STABILIZATION AND RECLAMATION
CLINTON CREEK MINE

R. M. Hardy & Associates Ltd.,

File No. K4232

Clinton Creek Mine Stability Analyses

Figure 1

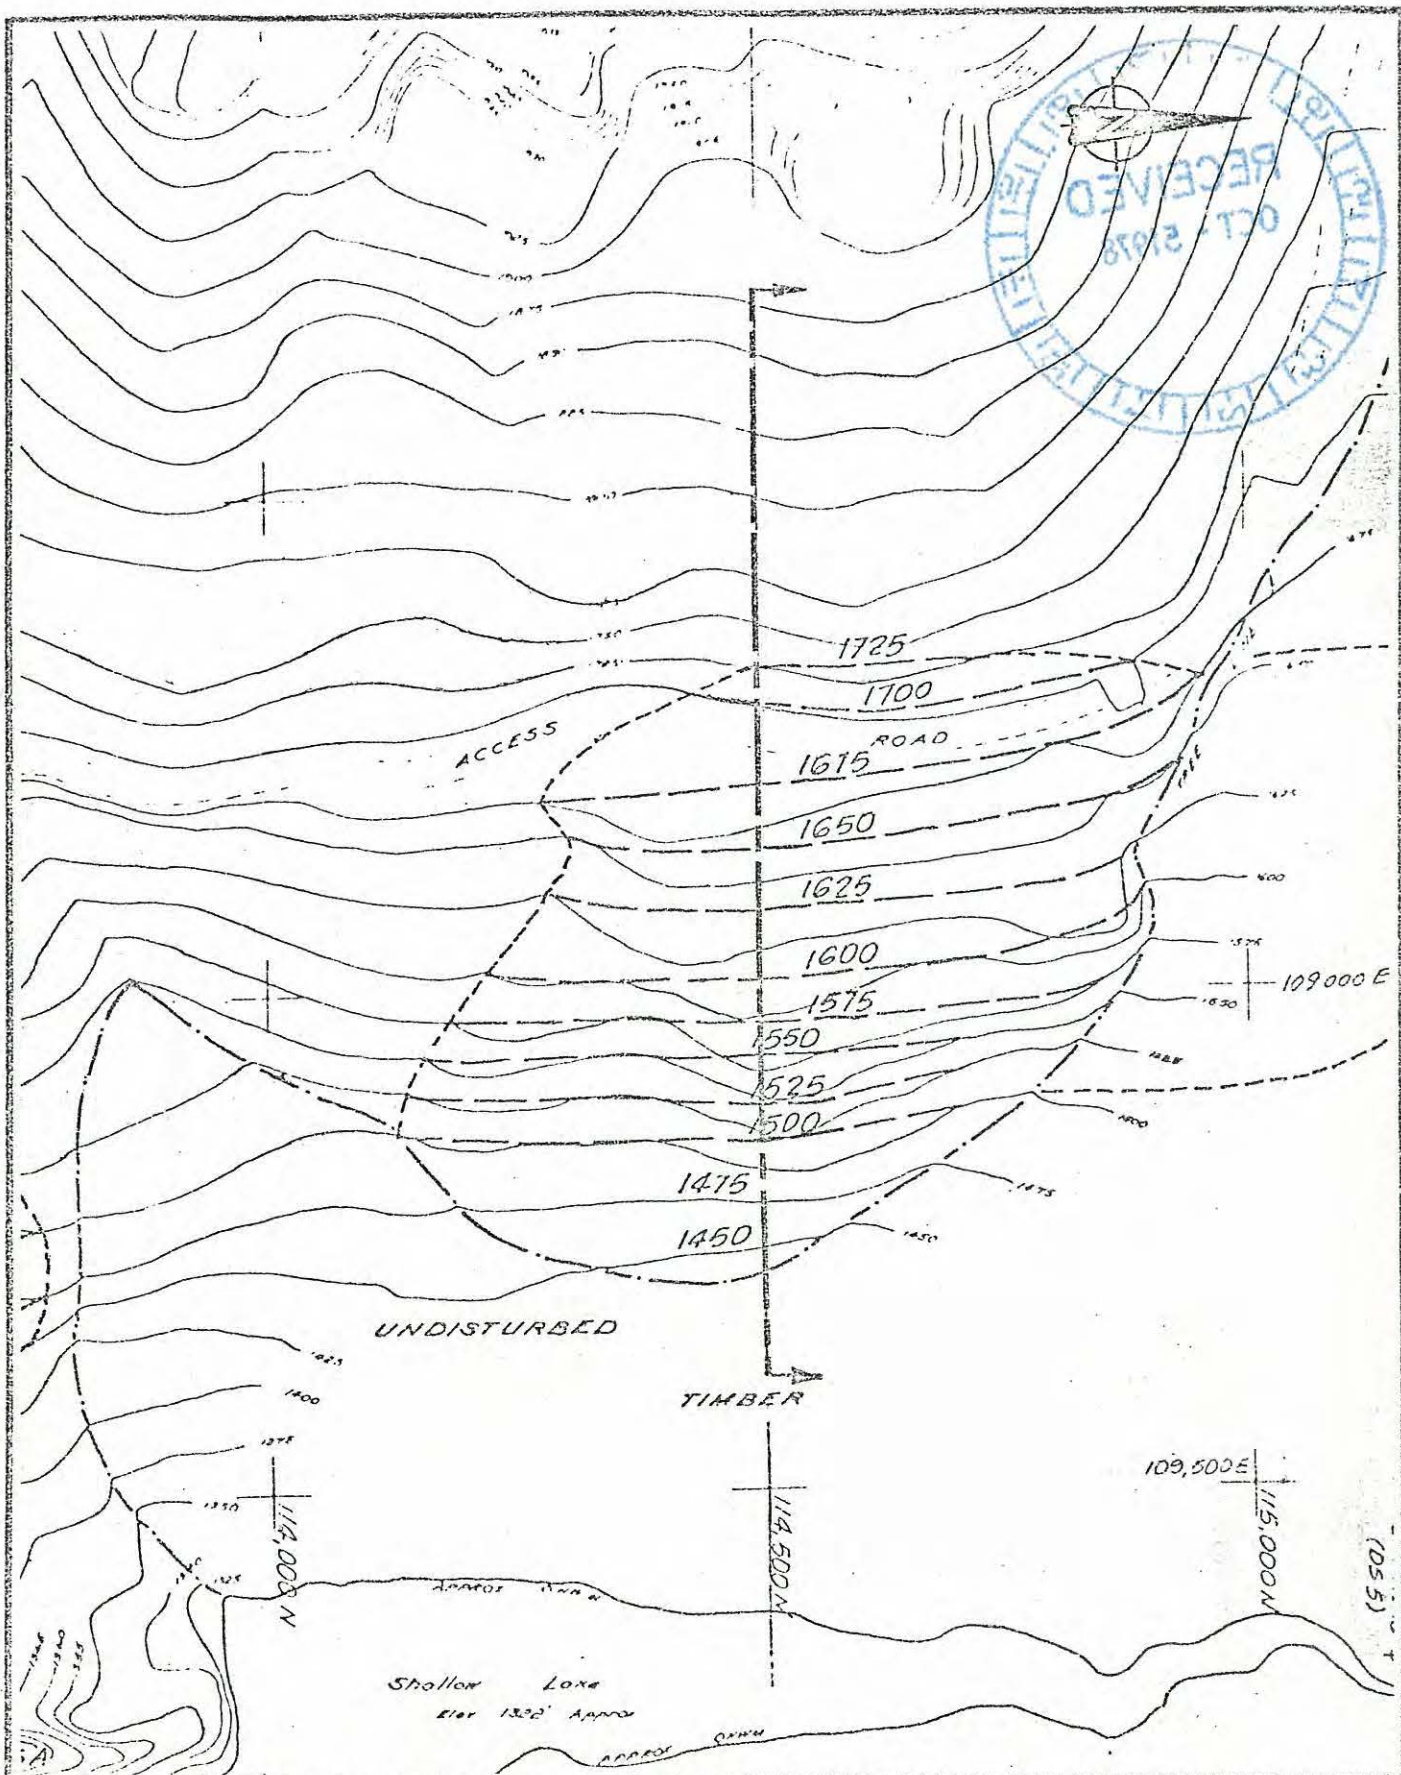
A section cutting through the north lobe of the tailings pile is analyzed. The location and the profile of the section are shown in Figs. 1 and 2 respectively. The elevations of original ground surface below the tailings are obtained from Fig. 8 of Golder & Associates' report (July 1978). Since there is no bore hole drilled at the section location, the thicknesses of "fluvial lacustrine (Golder report)" and weathered argillite strata are estimated from the information gathered in the vicinity.

No.	REVISION	DATE	BY
REFERENCES			
<div>  <div> R.M.HARDY & ASSOCIATES LTD. CONSULTING ENGINEERING AND PROFESSIONAL SERVICES </div> </div>			
<div> <div>CLINTON CREEK MINE</div> <div>STABILITY ANALYSIS</div> </div>			
SCALE As shown DATE Sept., 1978 MADE B.T. CHKD S.L. APPD.			
No. K 4232			2

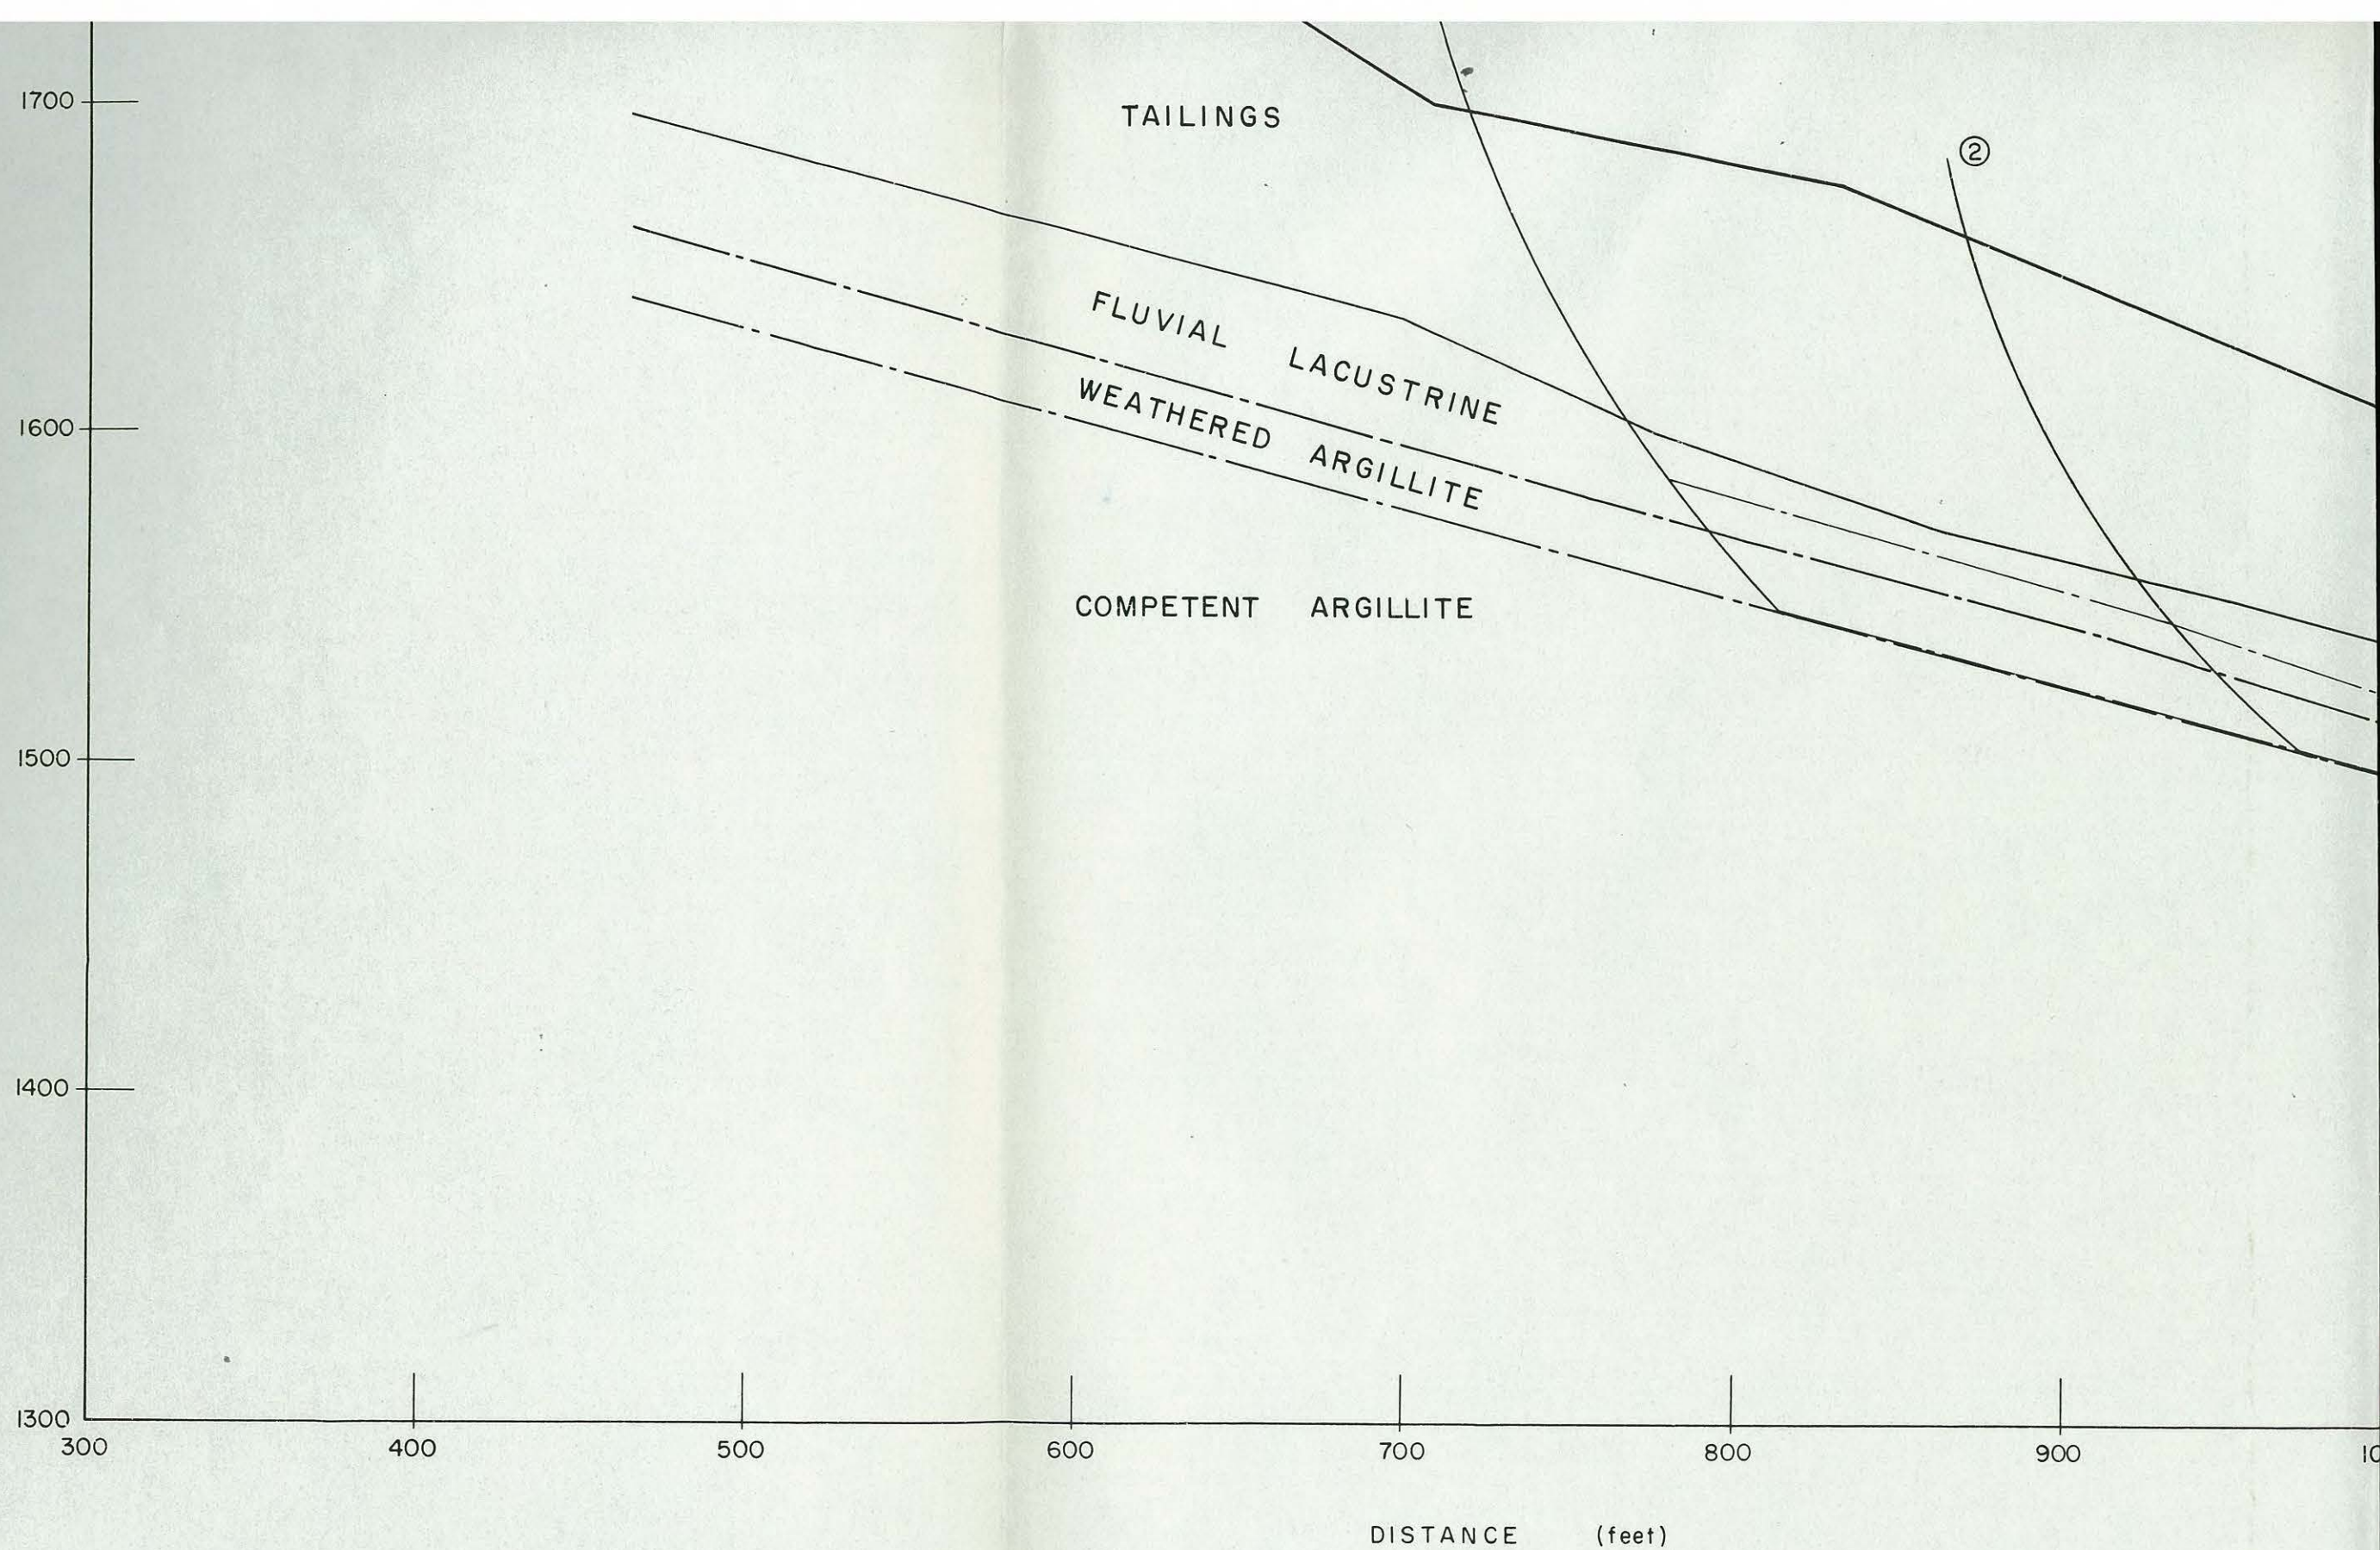
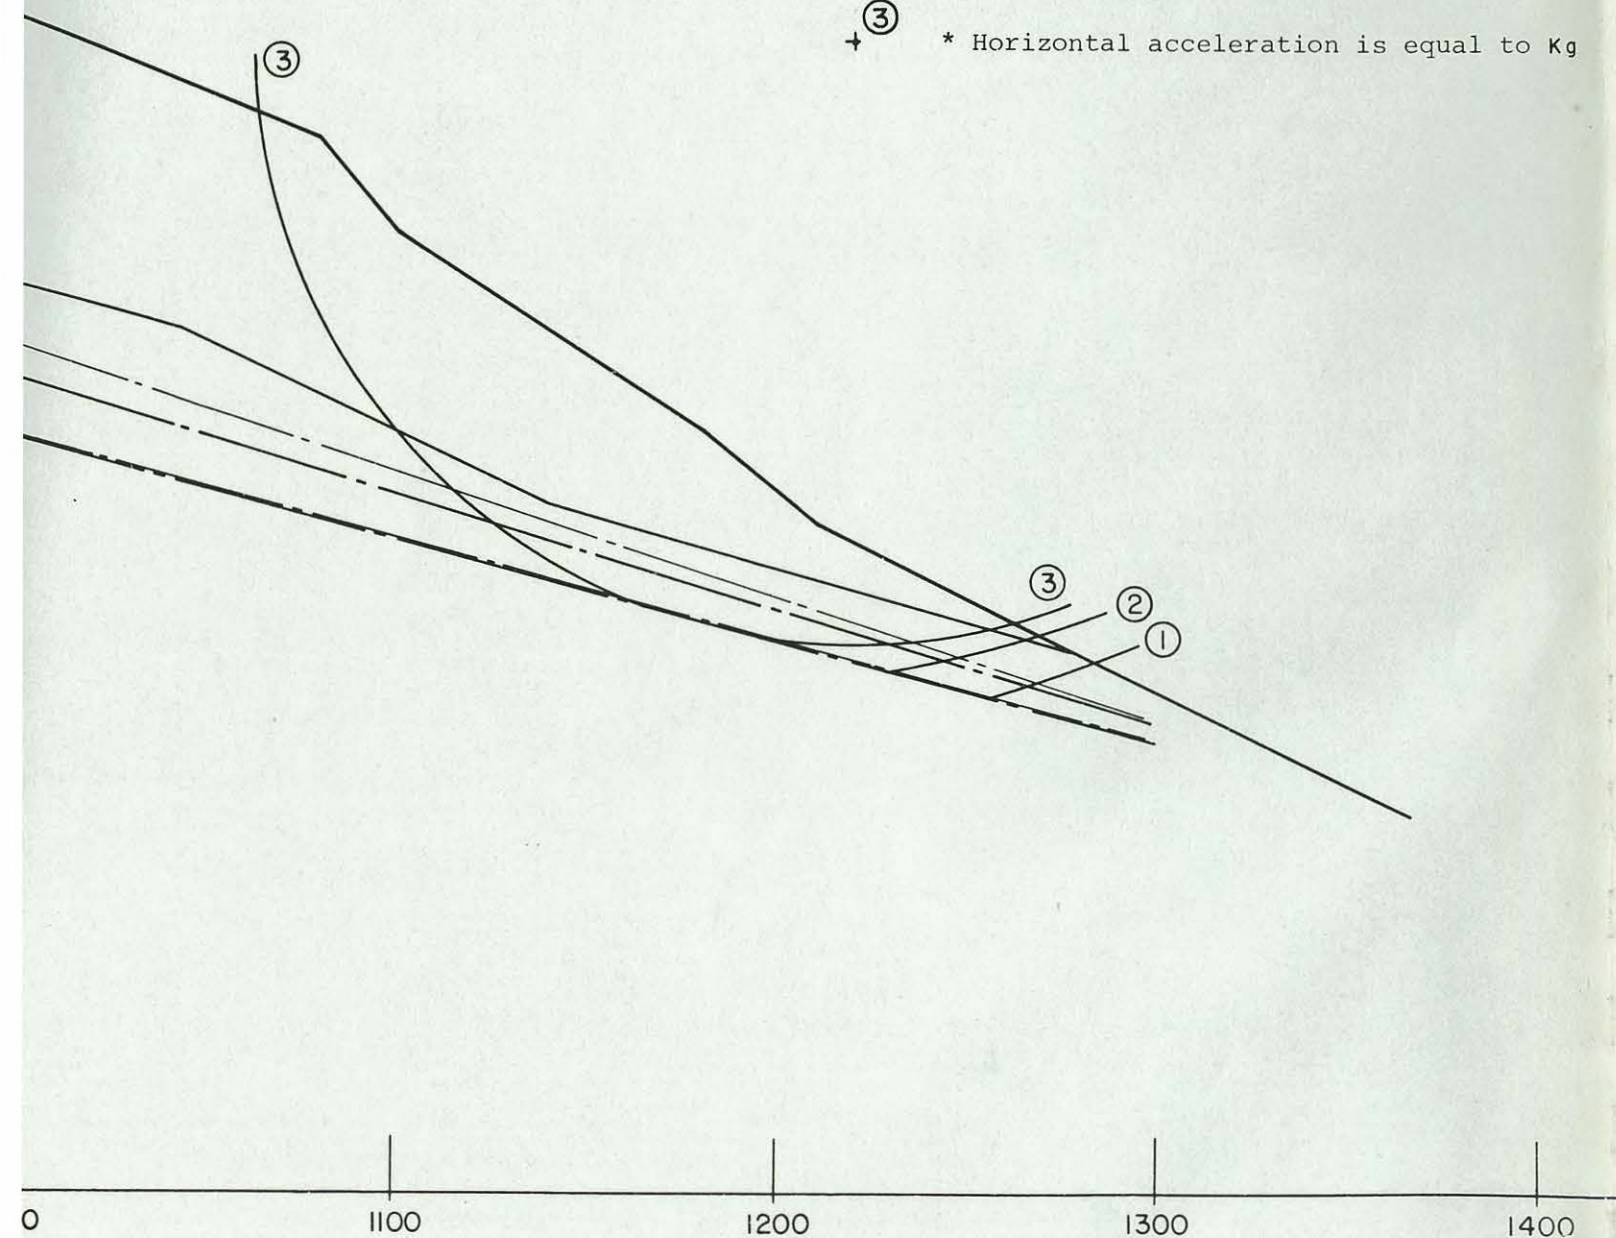
The analyses are performed with SLOPE (Fredlund, 1974) program using the simplified Bishop method. The mid-plane of the fluvial lacustrine layer and the interface of weathered and competent argillites have been assumed as the possible slip planes. A set of three slip surfaces which intersect each one of these planes are analyzed. The locations of these non-circular slip surfaces are shown in Fig. 2.

(r _u)	(K) *	1	2	Critical Slip Surface 3	
1	Tailings Fluvial Lacustrine	135 138	40 33	0 0.17	0 0	1.48	1.35	1.23	In order to obtain F.S.=1 for slip surface No. 3, it is estimated that r _u for fluvial lacustrine should be 0.33
2	Tailings Fluvial Lacustrine	135 138	40 33	0 0.41	0 0	1.01	0.94	0.89
